The Commission has issued the enclosed Amendment Nos. 39, 37, 48 and 47 for the Dresden Station Units Nos. 2 and 3 and Quad Cities Station Units Nos. 1 and 2, respectively, in response to your requests of September 10, 1974 and May 17, 1976, as supplemented March 21, 1977 and March 13, 1978.

The amendments revise Technical Specifications to provide operating temperature and pressure limits in accordance with Appendix G, 10 CFR Part 50.

UNITED STATES
NUCLEAR REGULATORY COMMISSION
WASHINGTON, D. C. 20555

AMENDMENT TO PROVISIONAL OPERATING LICENSE

Minimum Temperature Requirements per Appendix G of 10 CFR 50

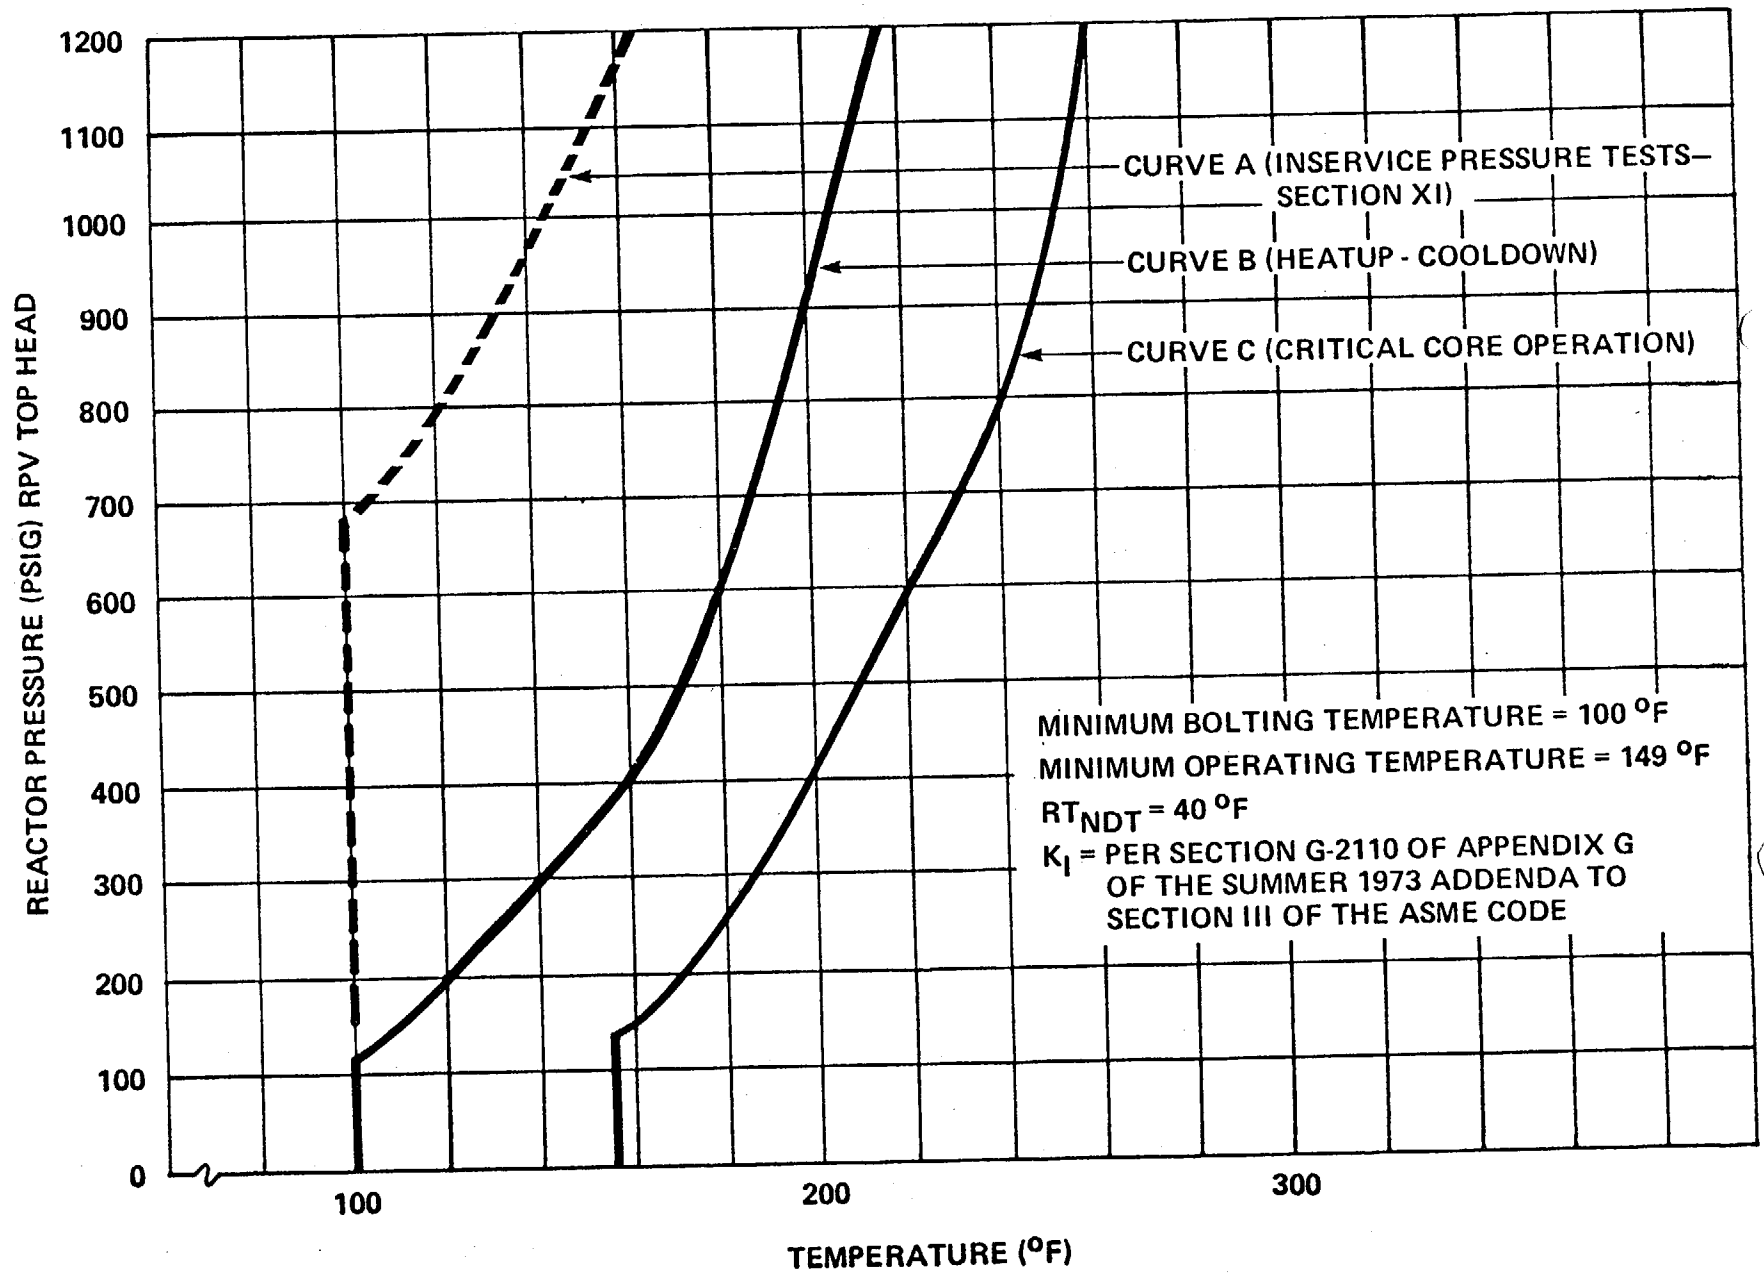
1. The reactor vessel shall be vented and power operation shall not be conducted unless the reactor vessel temperature is equal to or greater than that shown in Curve C of Figure 3.6.1. Operation for hydrostatic or leakage tests, during heatup or cooldown, and with the core critical shall be conducted only when vessel temperature is equal to or above that shown in the appropriate curve of Fig. 3.6.1. Figure 3.6.1 is effective through 6 effective full power years. At least six months prior to 6 effective full power years new curves will be submitted.
2. The reactor vessel head bolting studs shall not be under tension unless the temperature of the vessel shell immediately below the vessel flange is $\geq 100^{\circ}\text{F}$.

Pressurization Temperature - The reactor coolant system is a primary barrier against the release of fission products to the environs. In order to provide assurance that this barrier is maintained at a high degree of integrity, restrictions have been placed on the operating conditions to which it can be subjected. These restrictions on inservice hydrostatic testing, on heatup and cooldown, and on critical core operation shown in Figure 3.6.1, were established to be in conformance with Appendix G to 10 CFR 50.

Minimum Temperature Requirements per Appendix G of 10 CFR 50

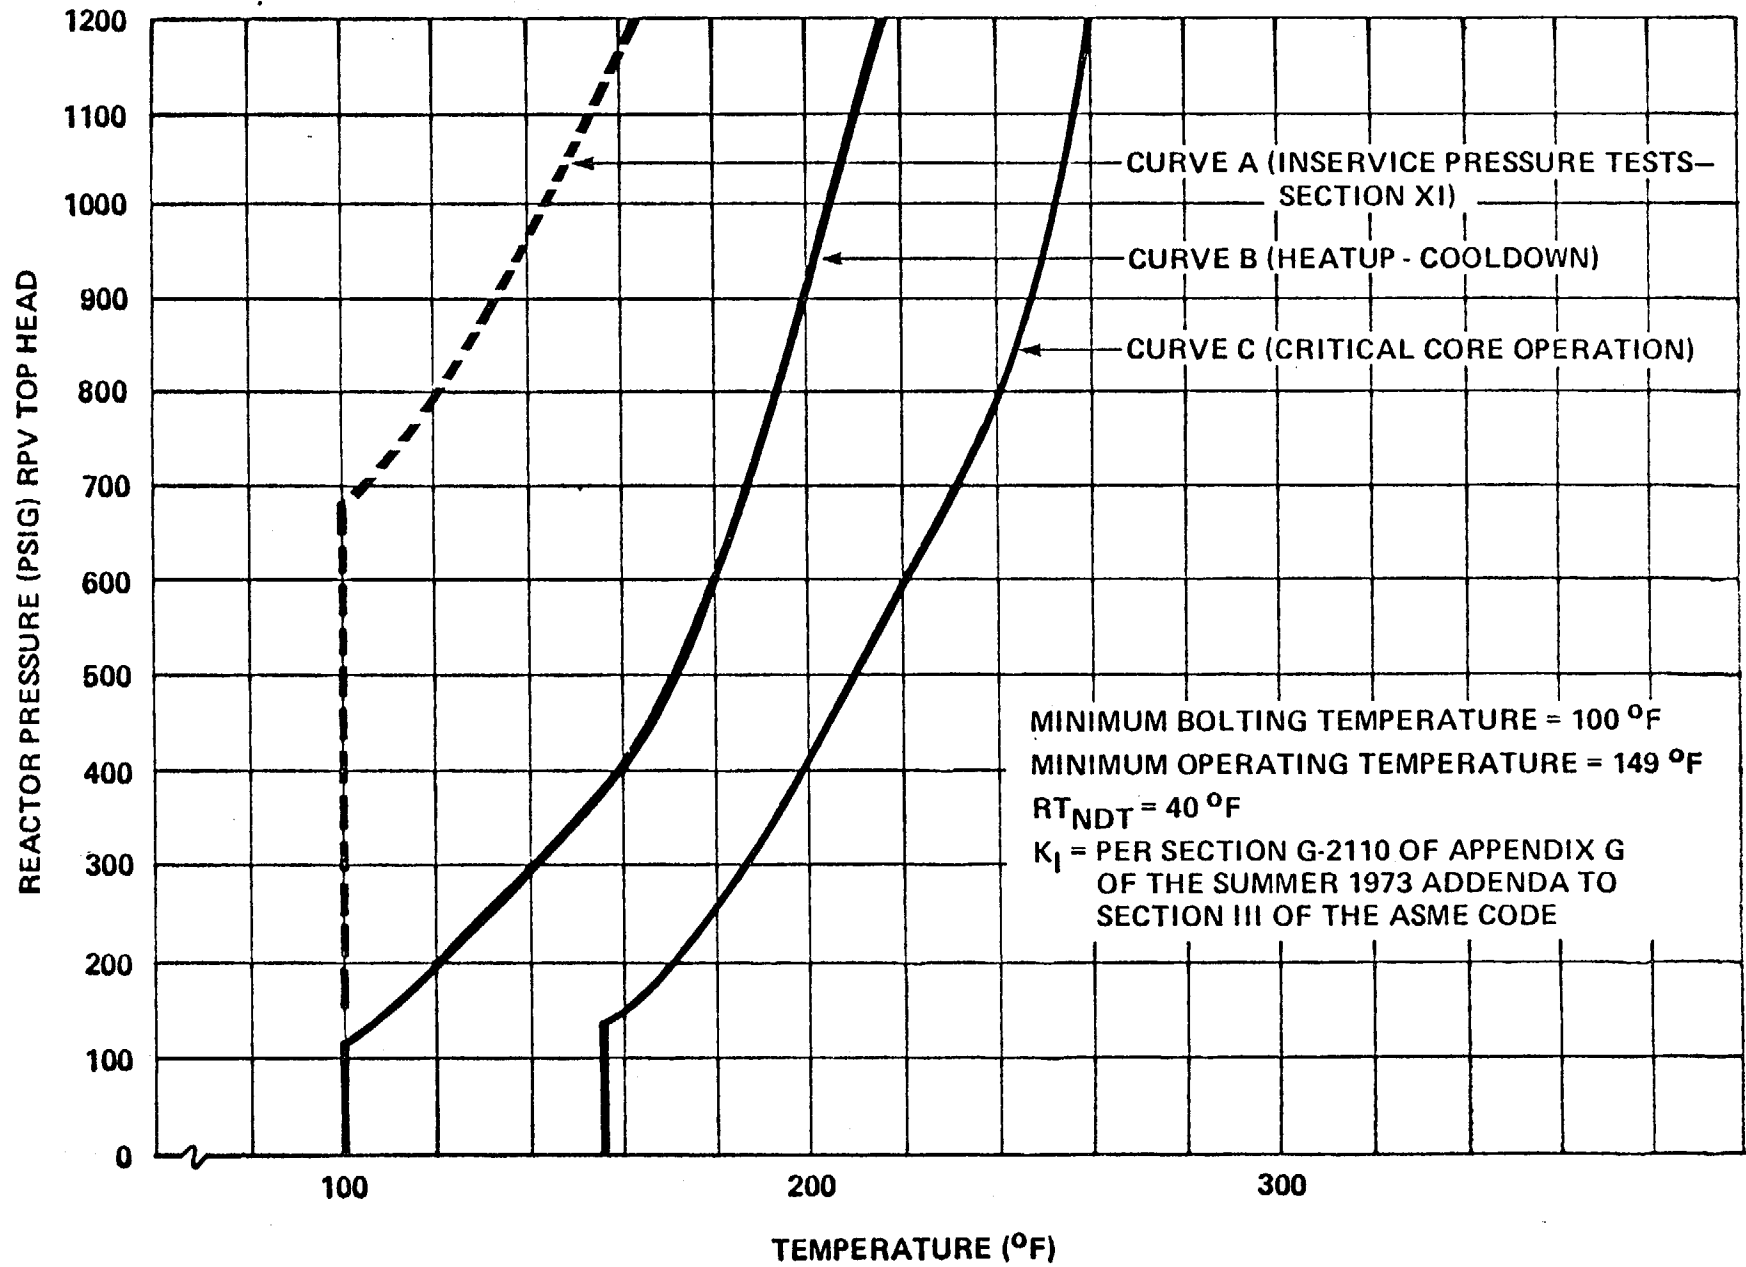
1. The reactor vessel shall be vented and power operation shall not be conducted unless the reactor vessel temperature is equal to or greater than that shown in Curve C of Figure 3.6.1. Operation for hydrostatic or leakage tests, during heatup or cooldown, and with the core critical shall be conducted only when vessel temperature is equal to or above that shown in the appropriate curve of Fig. 3.6.1. Figure 3.6.1 is effective through 6 effective full power years. At least six months prior to 6 effective full power years new curves will be submitted.
2. The reactor vessel head bolting studs shall not be under tension unless the temperature of the vessel shell immediately below the vessel flange is $\geq 100^{\circ}\text{F}$.

Pressurization Temperature - The reactor coolant system is a primary barrier against the release of fission products to the environs. In order to provide assurance that this barrier is maintained at a high degree of integrity, restrictions have been placed on the operating conditions to which it can be subjected. These restrictions on inservice hydrostatic testing, on heatup and cooldown, and on critical core operation shown in Figure 3.6.1, were established to be in conformance with Appendix G to 10 CFR 50.

Fig. 3.6.1

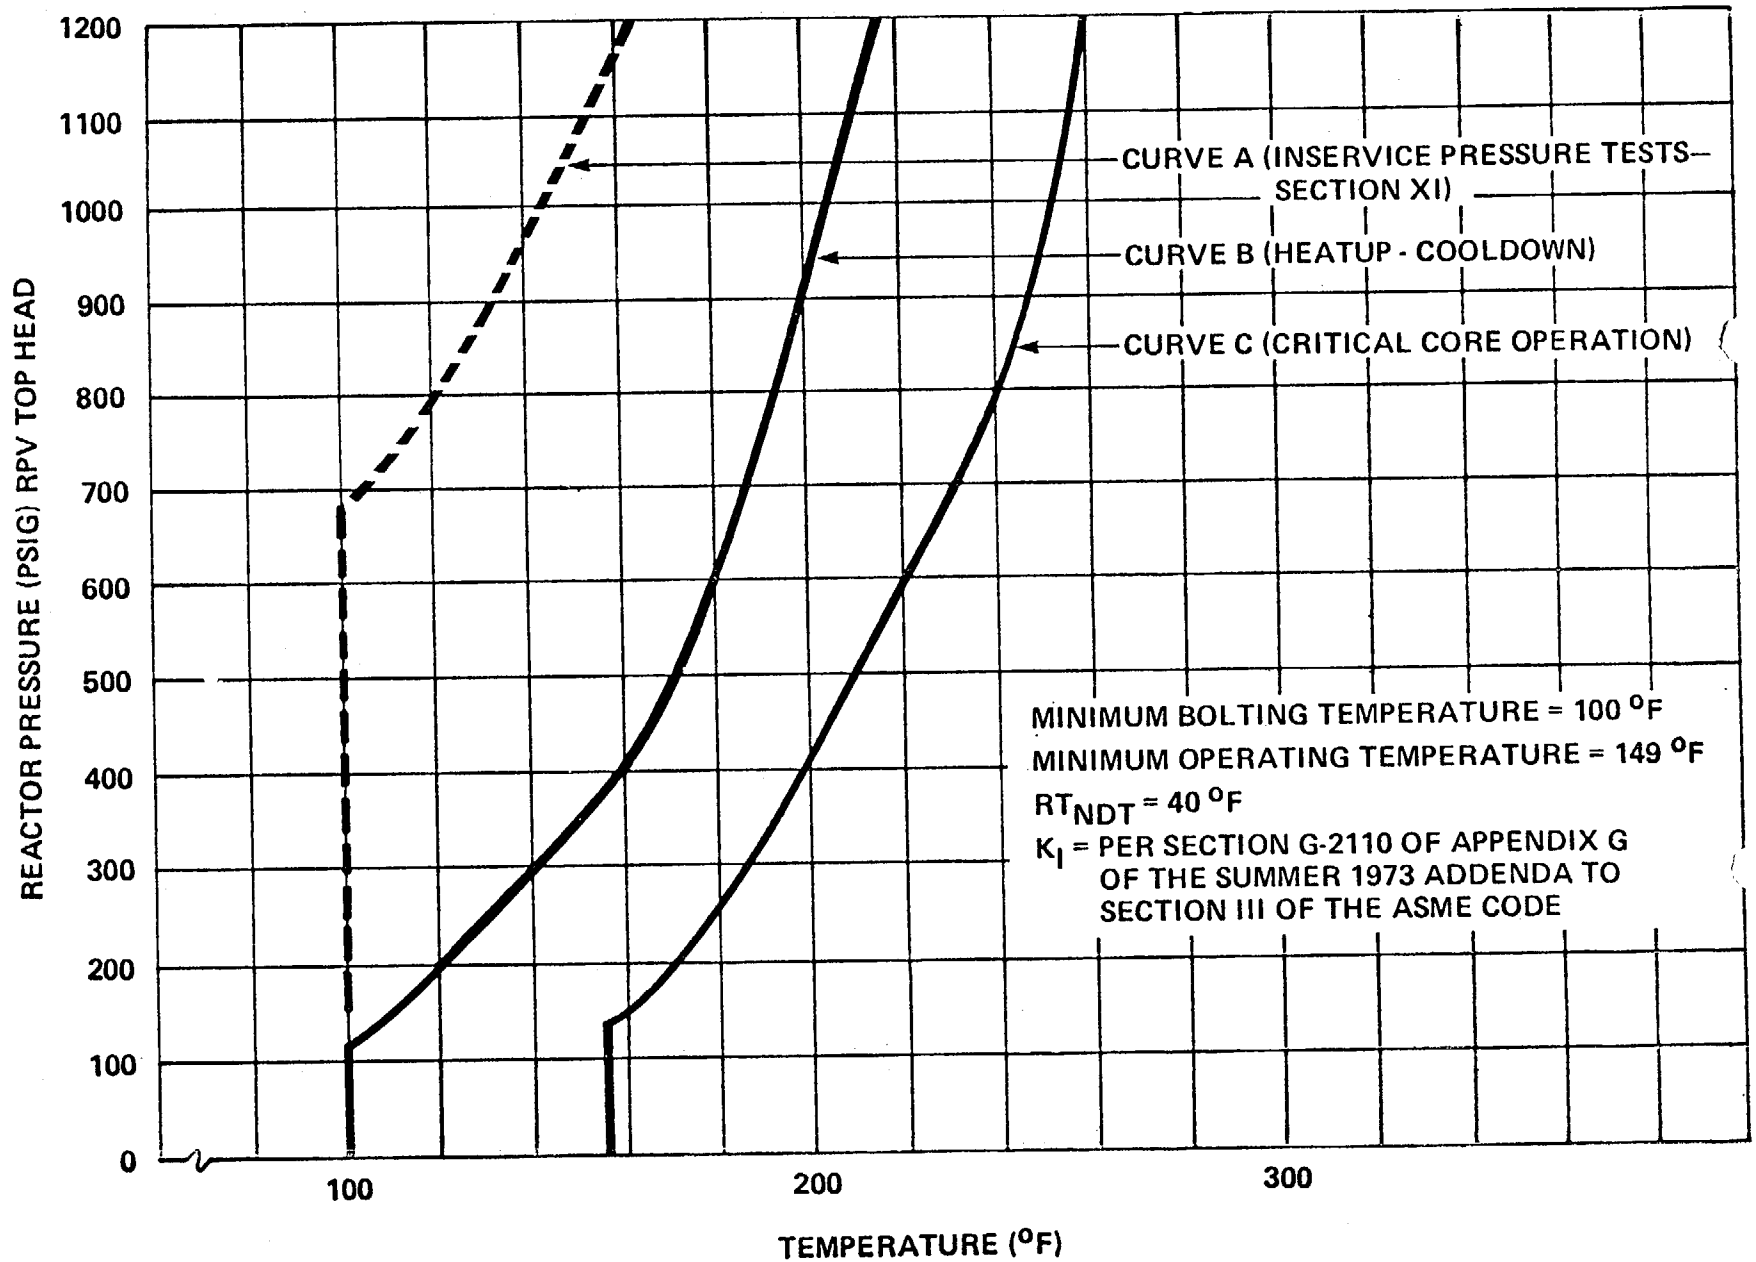
Operation for hydrostatic or leakage tests, during heatup or cooldown, and with the core critical shall be conducted only when vessel temperature is equal to or above that shown in the appropriate curve of Fig. 3.6.1. Figure 3.6.1 is effective through 6 EFPY. At least six months prior to 6 EFPY new curves will be submitted.

The reactor coolant system is a primary barrier against the release of fission products to the environs. In order to provide assurance that this barrier is maintained at a high degree of integrity, restrictions have been placed on the operating conditions to which it can be subjected. These restrictions on inservice hydrostatic testing, on heatup and cooldown, and on critical core operation, shown in Figure 3.6.1, were established to be in conformance with Appendix G to 10CFR50.

Fig. 3.6.1

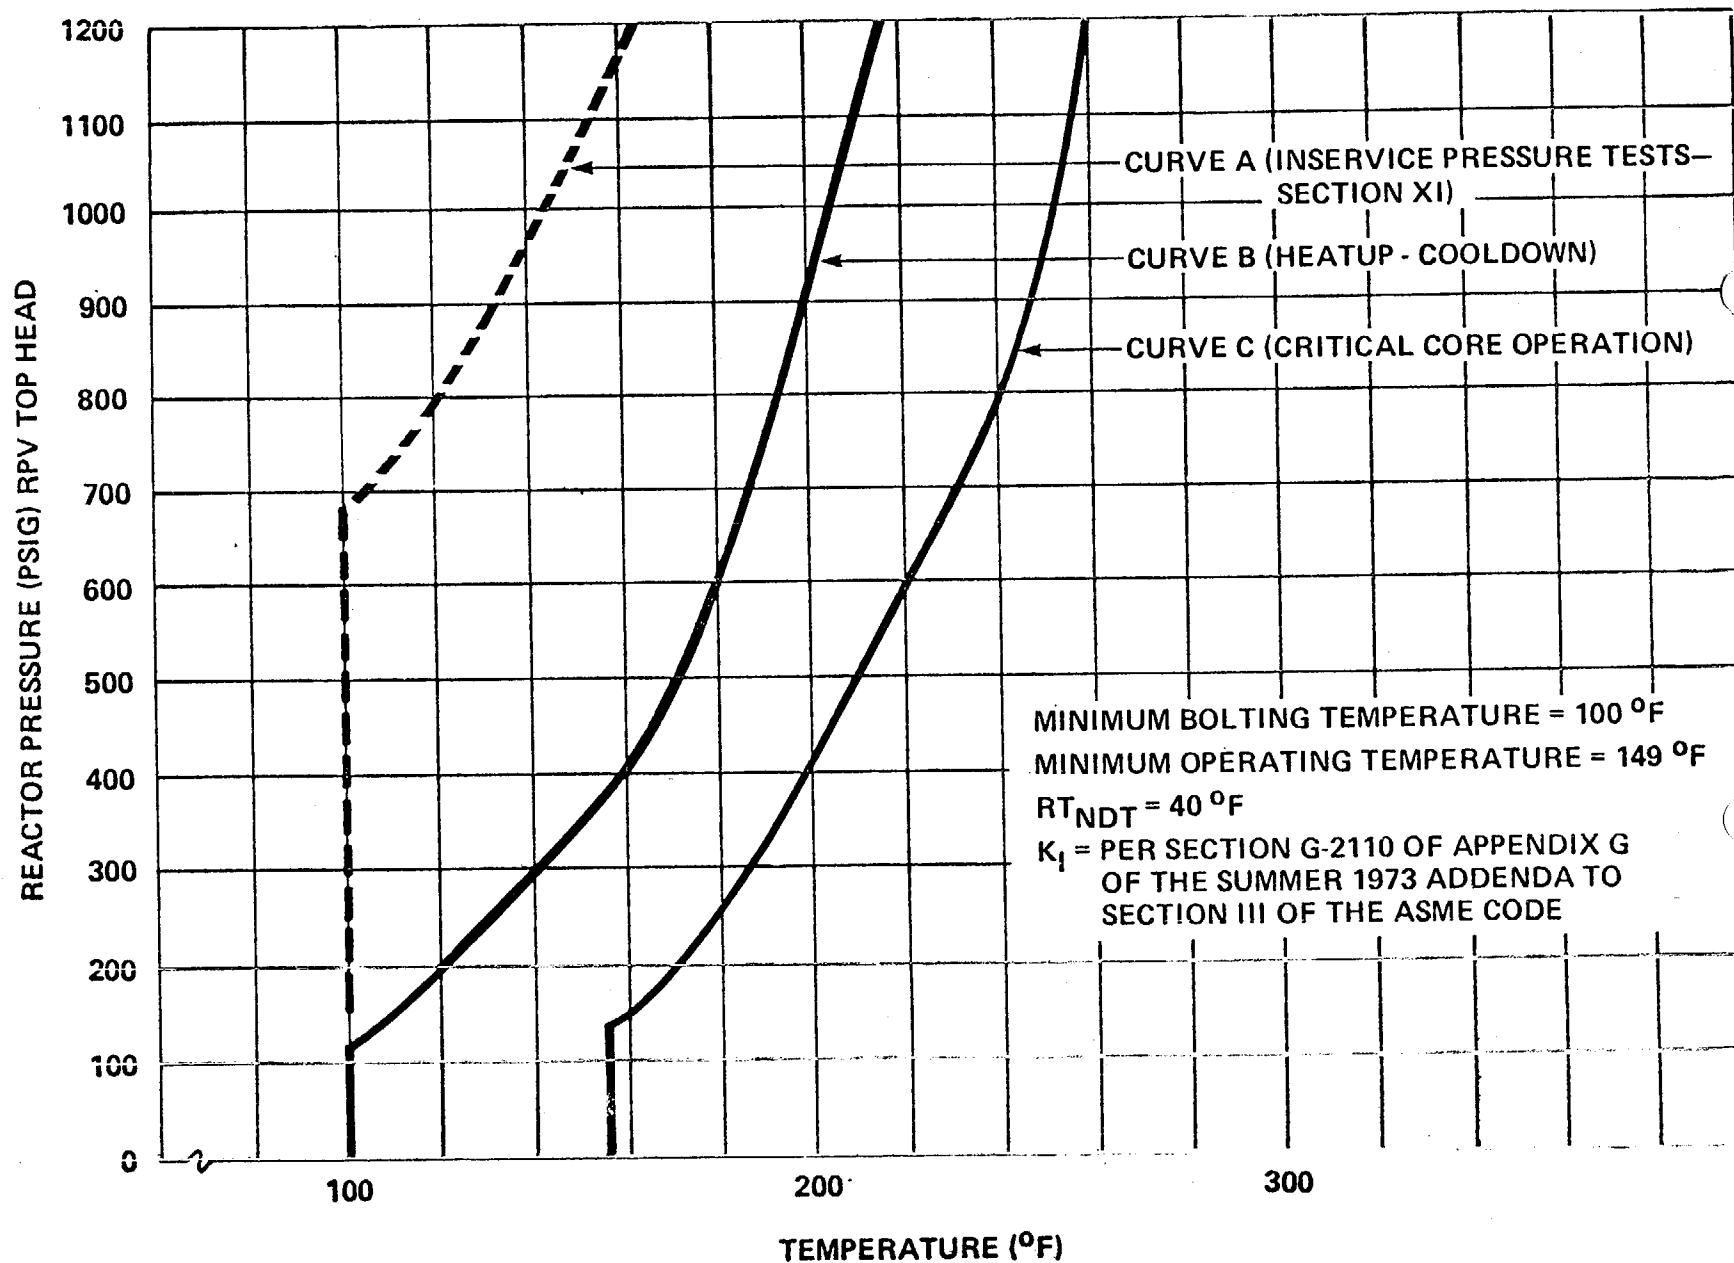
Operation for hydrostatic or leakage tests, during heatup or cooldown, and with the core critical shall be conducted only when vessel temperature is equal to or above that shown in the appropriate curve of Fig. 3.6.1. Figure 3.6.1 is effective through 6 EFPY. At least six months prior to 6 EFPY new curves will be submitted.

The reactor coolant system is a primary barrier against the release of fission products to the environs. In order to provide assurance that this barrier is maintained at a high degree of integrity, restrictions have been placed on the operating conditions to which it can be subjected. These restrictions on inservice hydrostatic testing, on heatup and cooldown, and on critical core operation, shown in Figure 3.6.1, were established to be in conformance with Appendix G to 10CFR50.
